In the Matter of
Niagara Mohawk Power Corporation
(Nine Mile Point, Unit 2)
Docket No. 50-410

ENVIRONMENTAL REPORT

OPERATING LICENSE STAGE NINE MILE POINT NUCLEAR STATION — UNIT 2

ACUTE FATALITIES-BWR COMPARISON

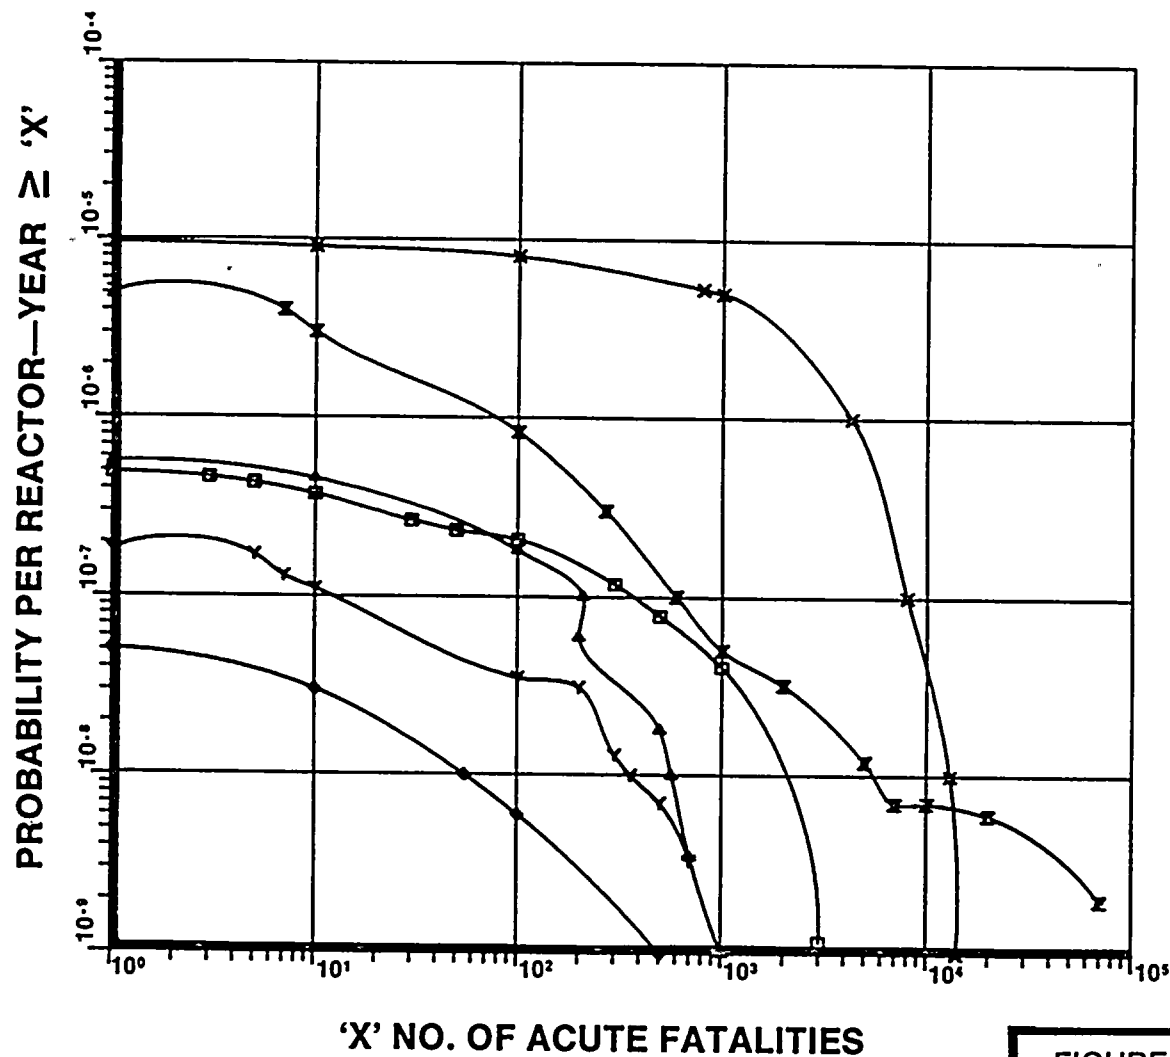
Figure 7A.6-9 includes data from the Grand Gulf Unit 1 Environmental Statement. Comparison of the CCDFs from the two documents indicates that the CCDFs in Figure 7A.6-9 may be for latent fatalities within 50 miles of the plant, and not for all those at risk from cancer. If so, this should be stated. A more complete depiction of latent fatality risk would include all those people who receive a dose that would increase their chances of a cancer fatality.

Grand Gulf Unit 1 data offered for comparison are taken from Figure 5.6 of NUREG-0777 labeled, "Within 50 Miles - Excluding Thyroid." Therefore, the CCDFs in Figure 7A.6-10, including five other plants, are only for the exposed population within 50 miles. This clarification has been added to Sections 7A.6.1 and 7A.6.2 and applies to all CCDFs calculated for Unit 2. Also, Figure 7A.6-6 depicting CCDFs for thyroid cancer within 50 miles of Unit 2 has been added.

LATENT FATALITIES-BWR COMPARISON

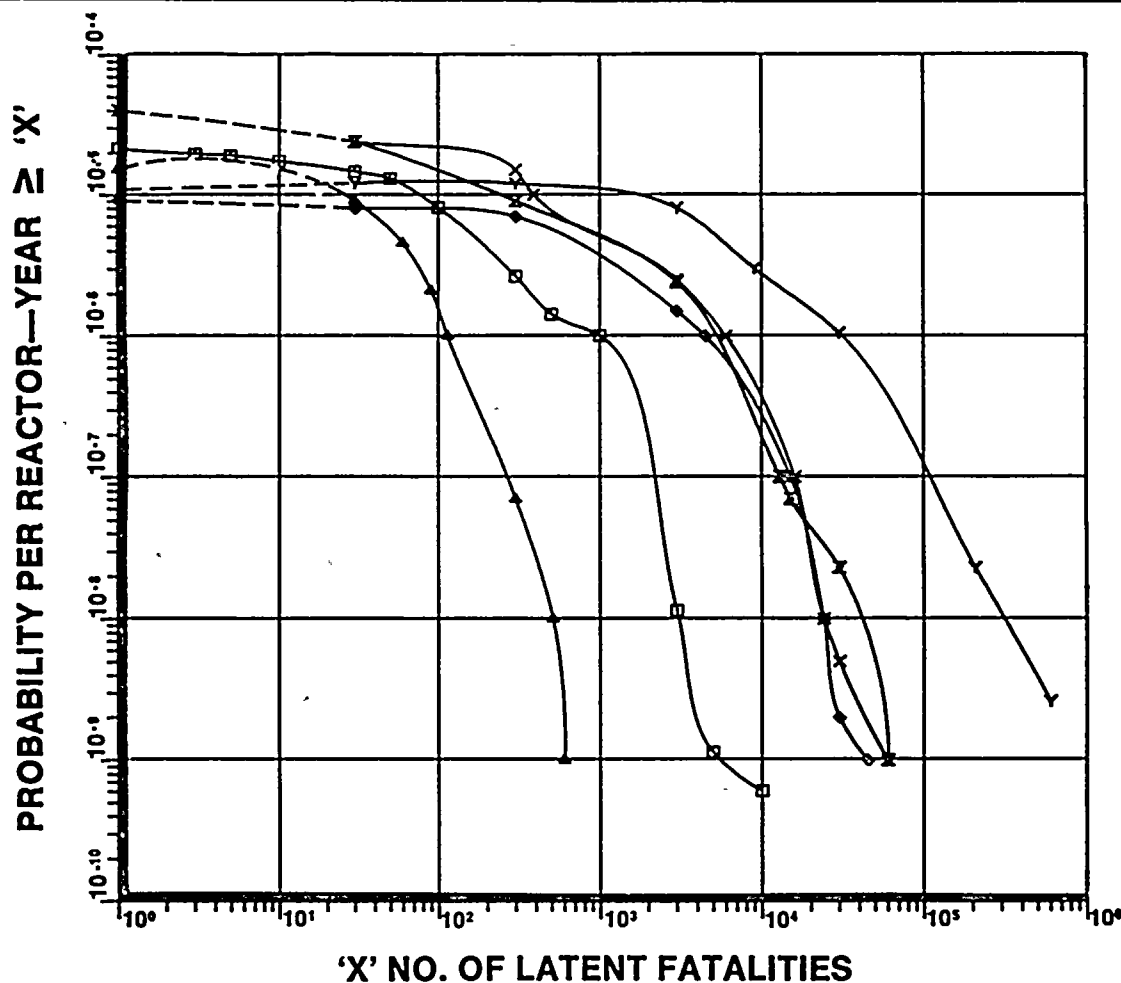
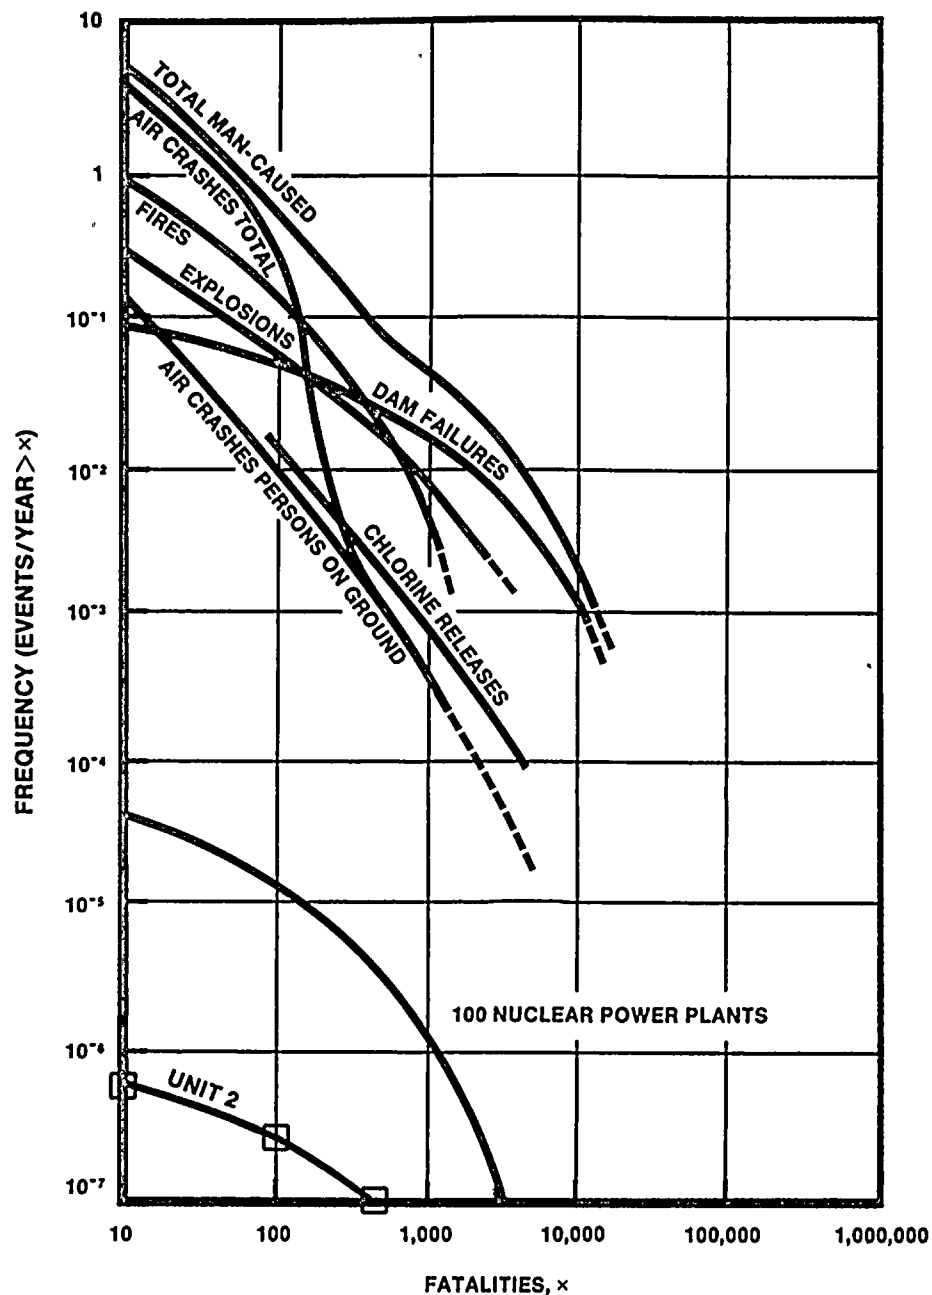
Figures 7A.6-10 and -11 show that at a 10^{-7} probability, the consequences of Unit 2 accidents are as large as from 100 nuclear power plants. This comparison may make Nine Mile Point look more risky than is realistic. Additional clarification should be provided.
